OCONEE NUCLEAR STATION, UNIT NO. 1

AMENDMENT TO FACILITY OPERATING LICENSE

Amendment No. 46
License No. DPR-38

ATTACHMENT TO LICENSE AMENDMENTS

Figure 3.5.2-103

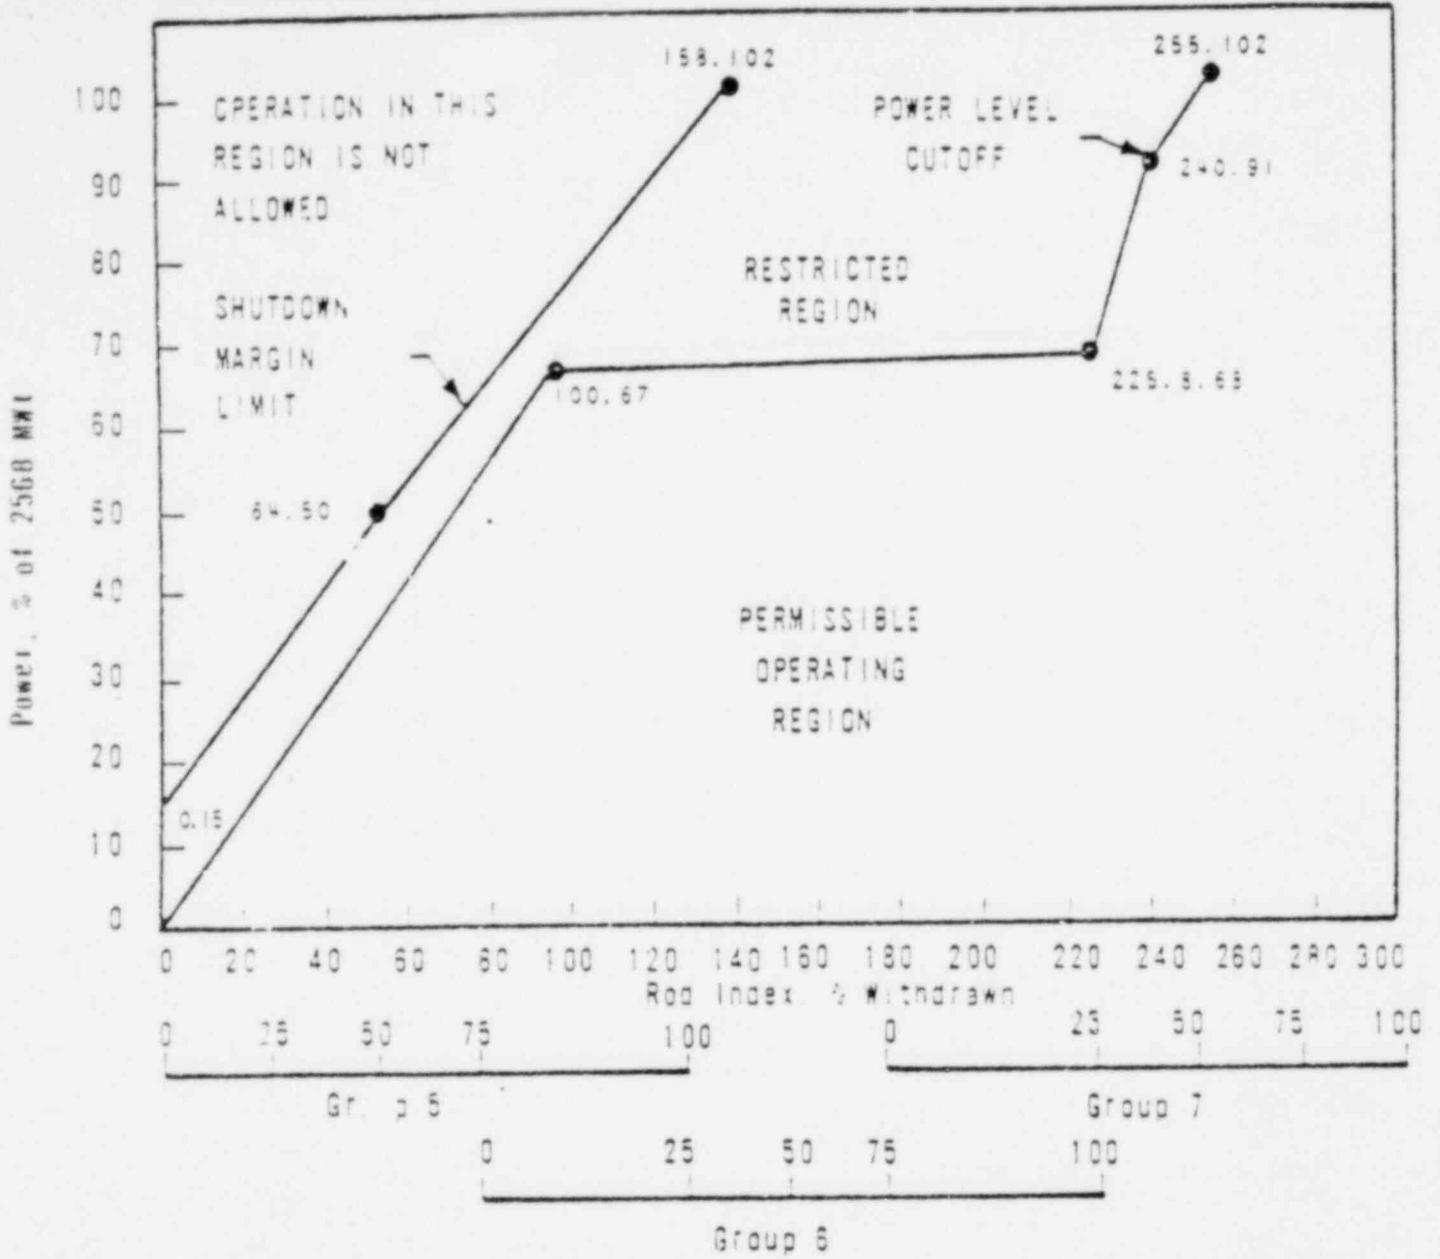
Remove pages 3.5-17, 3.5-2Jb and 3.5-23b and replace with identically numbered pages.

ROD POSITION LIMITS FOR FOUR-PUMP OPERATION AFTER 226(-10) EFPD Unit 3
